From: Kasturi Rangan <rirangan@yahoo.com>
Sent: Saturday, October 19, 2019 6:57 PM
To: Wardlaw, Mark
Cc: Sibbet, David
Subject: North County Environmental Resources Project PDS 2008-3500-08-015
Attachments: Signed letter KR to Mark Wardlaw 10192019.PDF; Dust from C & D processing facility.PDF

North County Environmental Resources PDS 2008-3500-08-015,

LOG NO. PDS2008-3910-0808012

Dust outside the gate of an existing recycling facility

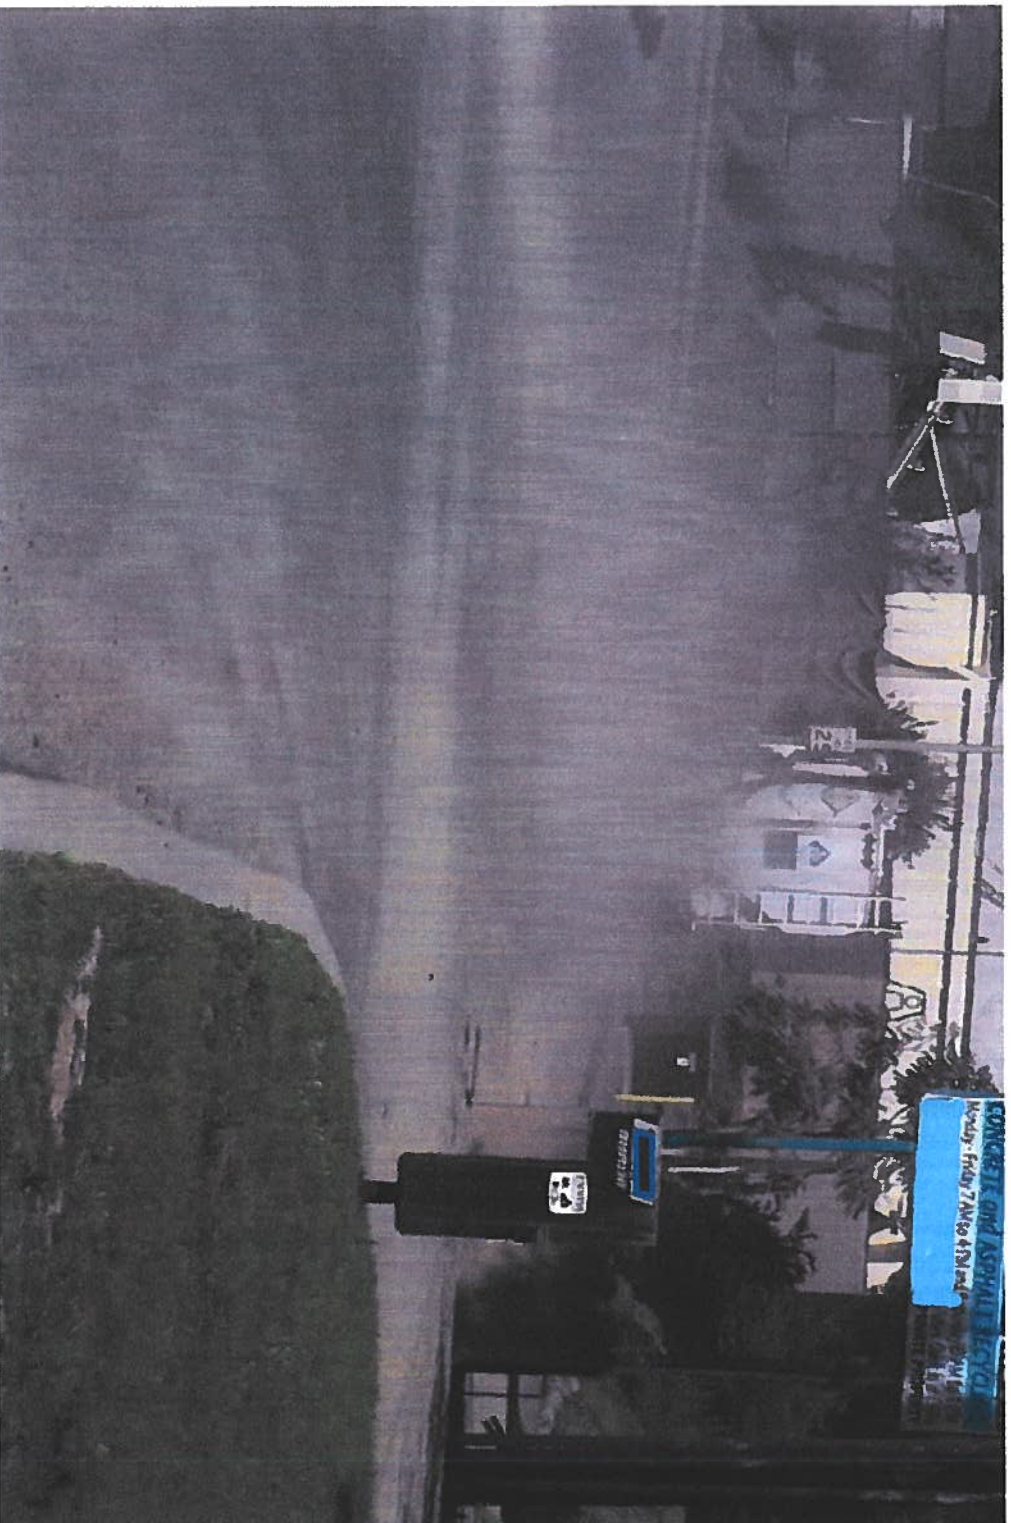
- There is a very loose definition in the documents submitted by the applicant relating to mitigation of fugitive dust emissions by use of water with vague statements about use of misting devices or use of water trucks. This use of water needs better description in terms of facilities used and the system that will be installed to provide the water at the required pressure for misting at operating equipment and at intermediate as well as product storage piles. Will the use of water be interlocked with the operating equipment in a way that the equipment cannot be turned on without water misting in action? How many water trucks will be in service? What is the capacity of each truck? Here again a lack of dust monitoring equipment leaves too much to the discretion of the operator – much dust can be released while an operator is trying to figure out why his misting devices are not working. Visual monitoring by the operator is inadequate.

- The need for electronic monitoring facilities has been pointed out in several sections of the comments made above. The point to be emphasized here is that the technology for such monitoring is available and has been for some time. There is no reason not to make this a requirement for a facility that is to be located in a pocket Industrial Zone in the middle of residential areas. Such monitoring devices would allow the facility to operate to meet its needs while protecting the community from known impacts and hazards and relieving them of the burden of having to report inordinate or unintended violations to County authorities. This would better serve the spirit and objectives of the General Plan Update. Lack of such facilities would be a strong reason to deny the permit. To support my argument for appropriate monitoring and recording equipment, I attach a photograph taken a few years ago of the street entrance/exit to an existing C & D recycling facility. This exemplifies the disparity between intentions to operate properly and actual site conditions.
